NEW ALBANY
COMMUNITY CONNECTS US
Planning Commission Staff Report
July 20, 2026 Meeting

EDGEHILL
PRELIMINARY AND FINAL DEVELOPMENT PLAN

LOCATION: Generally located south of State Route 161, north of East Dublin-Granville Road, west of Kitzmiller Road, and east of Johnstown Road/U.S. Route 62. (PID: 222-000238).
APPLICANT: M/I Homes c/o Joe Looby, EMH&T
REQUEST: Final Development Plan with Waivers
ZONING: Ganton Comprehensive-Planned Unit Development (C-PUD)
STRATEGIC PLAN: Village Center
APPLICATION: FDP-04-2026

Phase Plan

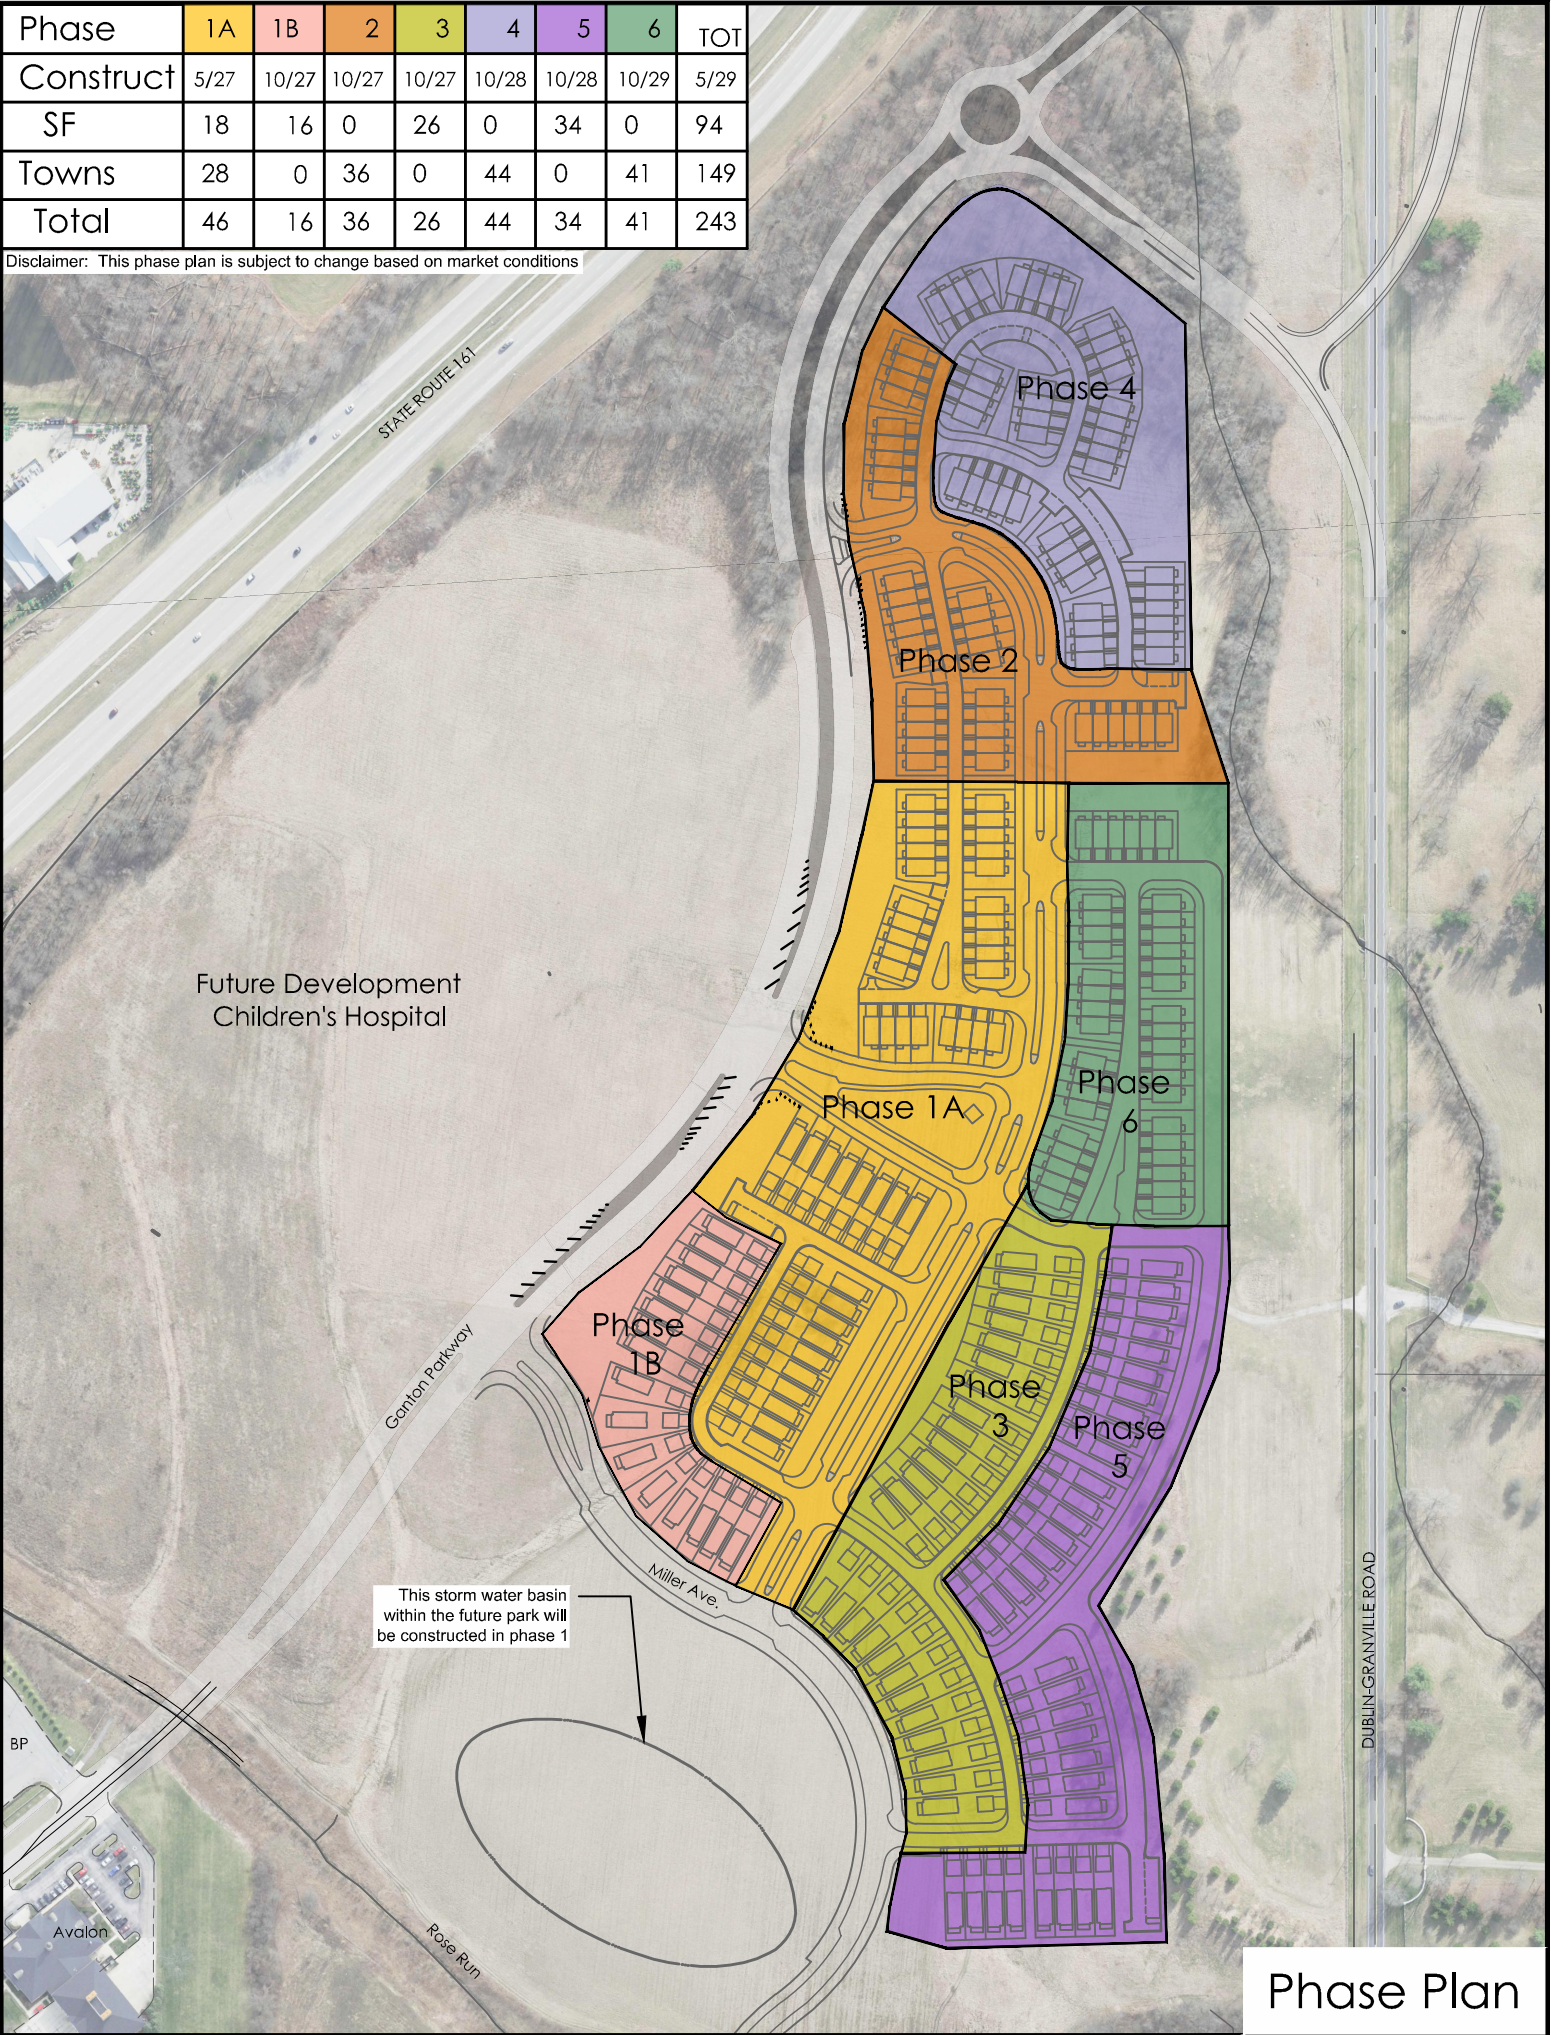
- These proposed residential uses are broken up into 7 different phases illustrated in **Exhibit I (Phase Plan)**.
- The development text permits a maximum of 294 residential units which is the same number permitted in Subarea 3D of the 1998 NACO PUD prior to the approval of this zoning text. Any permitted but undeveloped units in Subarea 3 maybe be deposited into the NACO "housing bank" that was created under the 1998 NACO PUD for transfer and development into other locations with the city. The applicant proposes a total of 243 units (4.16 units/acre), with the distribution across the different phases shown in the table below:
